Report on a Publicly Notified Resource Consent Application

(Section 42A)

Application Reference: RMA/2024/3209

Proposal: Establish a new commercial centre containing a supermarket, smaller scale retail activities, amenity spaces and carparking and to undertake earthworks on land with contaminated soils

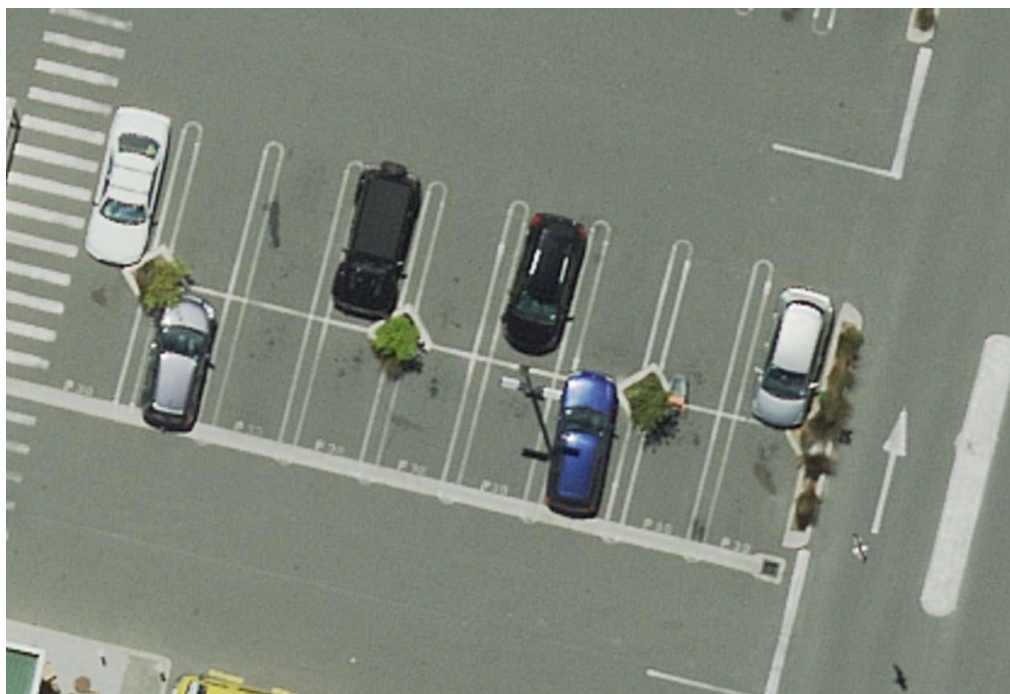
All the proposed plant species and their generic locations by area are listed in the Boffa Miskell Landscape Design Report on pages 17 – 19 with updates included in the RFI response. All plant species proposed will thrive at the site, subject to best practice planting site preparation, plant quality and ongoing maintenance. Of note the majority of the proposed tree and shrub species and several of the 'low shrubs / groundcovers / ferns' plant species are locally indigenous to this wetter part of Christchurch which is commended. There are also several native hybrid and exotic species proposed which will 'do' well at the site also. I note that Hinau and Red beech have been replaced with other

smaller native and exotic tree species in response to the RFI. In my opinion, Hinau and Red beech would do well at the site and I commend the Landscape Architect's intent to include some long-term 'noble' native trees. However, they would do best in suitably large planting sites well away from buildings, building footings and hardstand areas. They are also ultimately very large trees which may be problematic over time in terms of shading adjacent public and residential areas.

Other than the proposed trees which are located on the plans, no proposed plant spacings are provided. It is assumed that the intent is for the planted areas to quickly 'mass up' in low shrubs and ground covers to provide rapid amenity, minimise weed invasion and reduce ongoing maintenance. However, plant spacings would be helpful to be provided to provide certainty that the areas will contribute maximum levels of amenity in as short a timeframe as possible. It is noted that mature plant sizes are included in the plant palette species lists which is helpful.

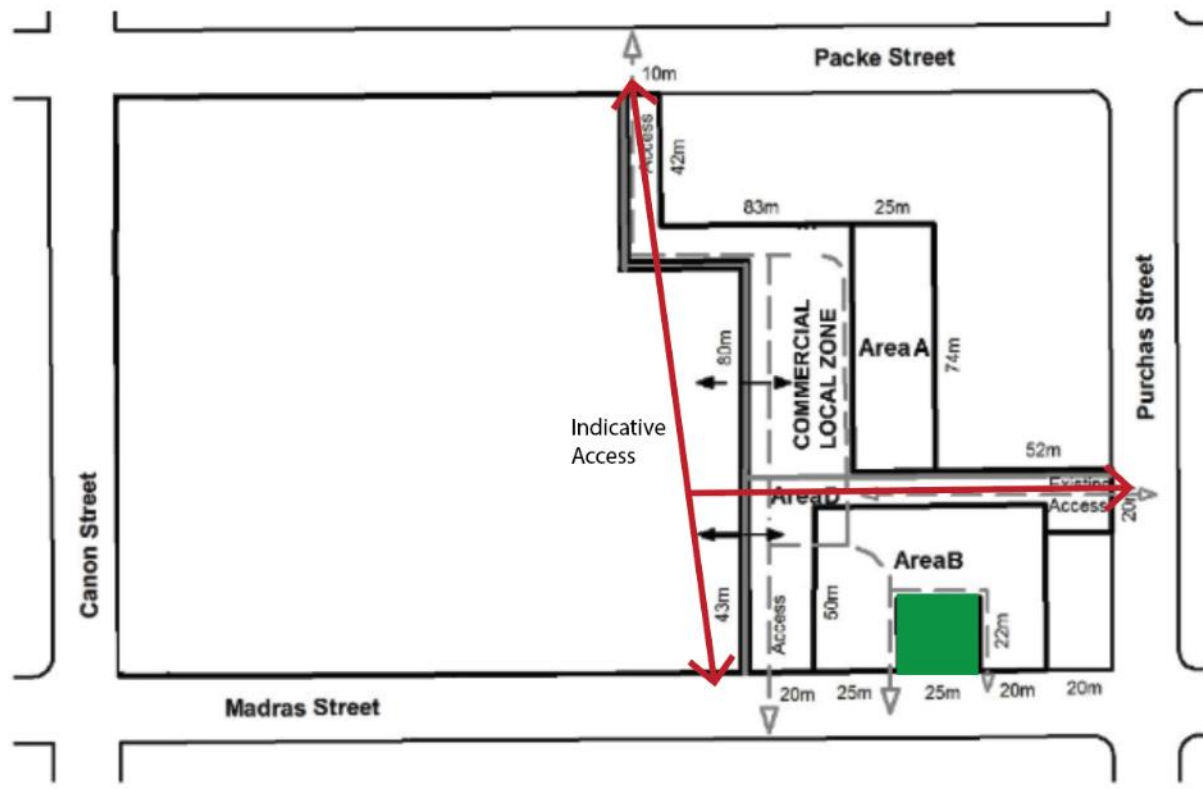
I disagree that the current state of the site is an important consideration. Instead, I think the relevant consideration is whether the site achieves the expected outcomes in the plan. In any case I disagree that the site currently has a particularly negative impact on amenity. It is open ground which appears vegetated. It is not typical of a suburban area but it does not detract from it – it would be more accurate to say it does not make a positive contribution.

Consequently, it is not self-evident that the proposed development could be seen as an improvement in terms of amenity (although it may have other benefits).

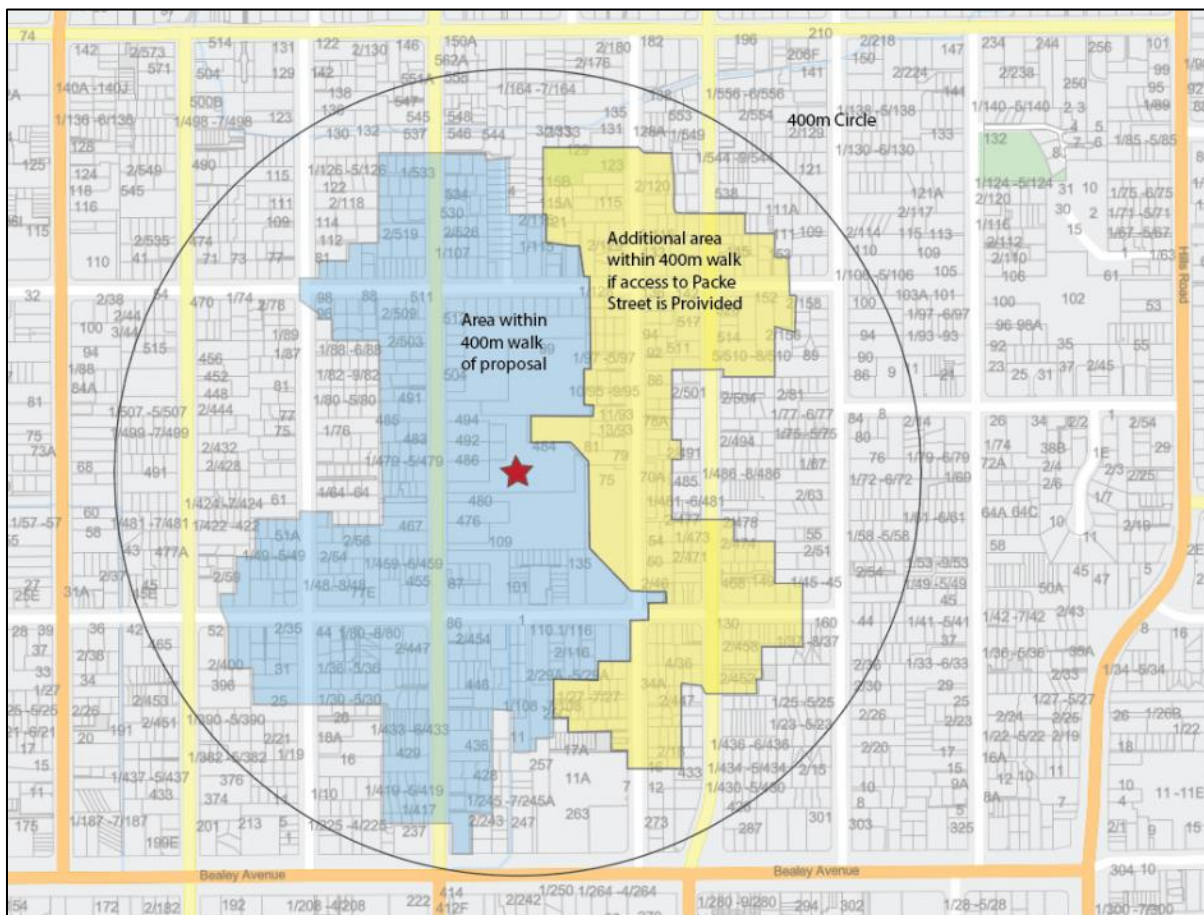
The loading dock fence will be visible from Packe Street and will affect the neighbouring site, as is acknowledged by Mr Church. From the street it will be quite harsh in appearance and although its scale will be mitigated by the distance of its setback, there is currently no proposal to landscape in front of it to manage this. I consider that there will be a low impact on the public realm because it will be set back and the angle of view is narrow. However, this is not the case for the neighbouring site, which will have a much greater degree of exposure, notably on entry to their site.

Finally, Mr Church has not discussed the impact of site layout and parking, which makes a considerable contribution to the overall appearance of the development. I have largely discussed these issues in my comments on section 4.2, but the impacts are also relevant with respect to built form and appearance.

Diagram 5: Concept 1C

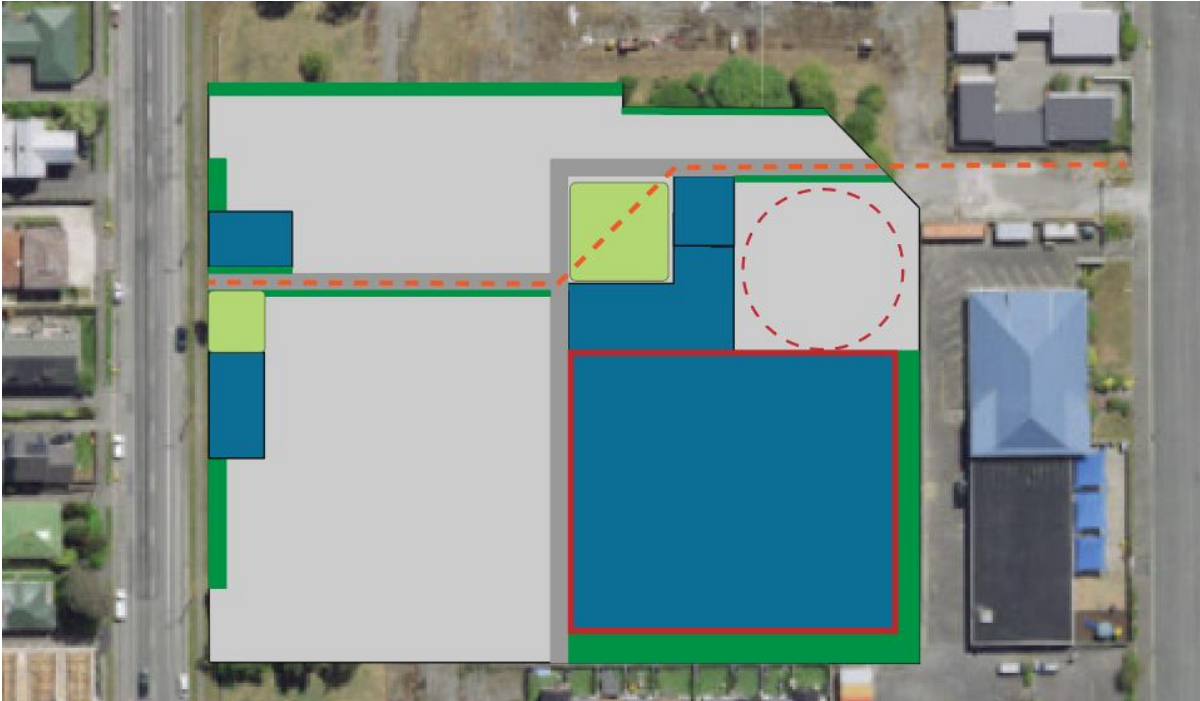
This concept splits the plaza in two, and provides a more direct connection through to Packe Street via the plaza. This latter feature would make sure the connection was useful and safe.

Diagram 6: Concept 1D

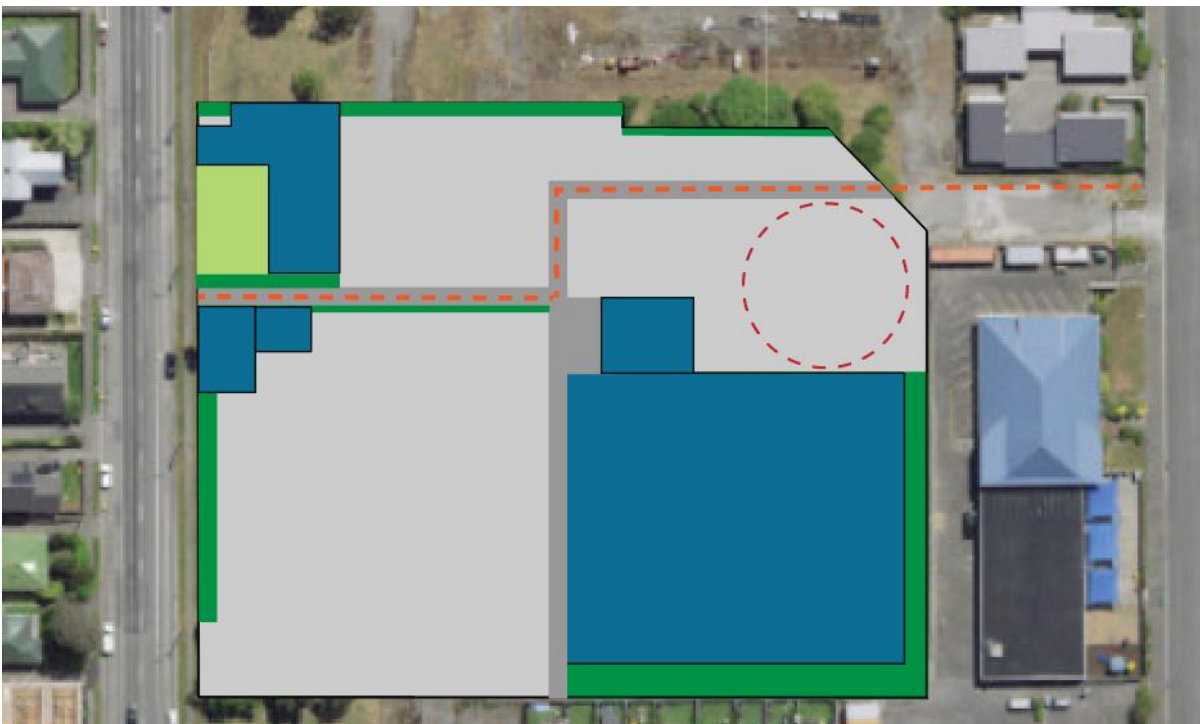
This concept provides for a more direct walkway. It can also be an advantage to place the back of the smaller buildings to the edge of the site so that they are not exposed to public view, and safety issues at the back can be avoided. However, it biases the centre to the north (where land is not zoned commercial), which may be a disadvantage.

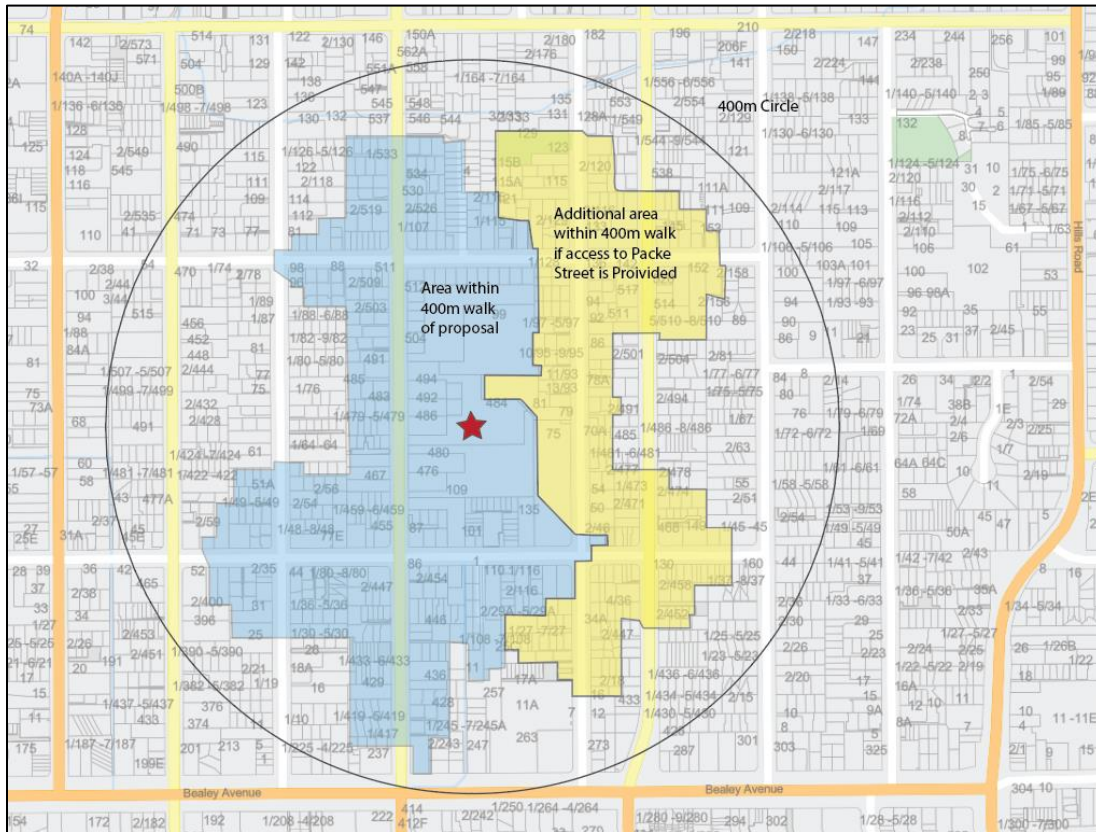
16. Pedestrian access to the site is only provided from Madras Street which does not comply with the ODP which planned further access points from Packe Street and Purchas Street. The opportunity to provide a safe and convenient access for pedestrians and cyclists to encourage non car-based travel is lost if not provided.
17. Regarding the access from Madras Street, it is likely that pedestrians would choose to enter the car park through the vehicle access and with no facilities for pedestrians at the access, could lead to safety issues at the access for pedestrians and their presence will affect the efficiency of the accesses. Given this and the non-compliance with the ODP pedestrian access from Madras Street should be improved.
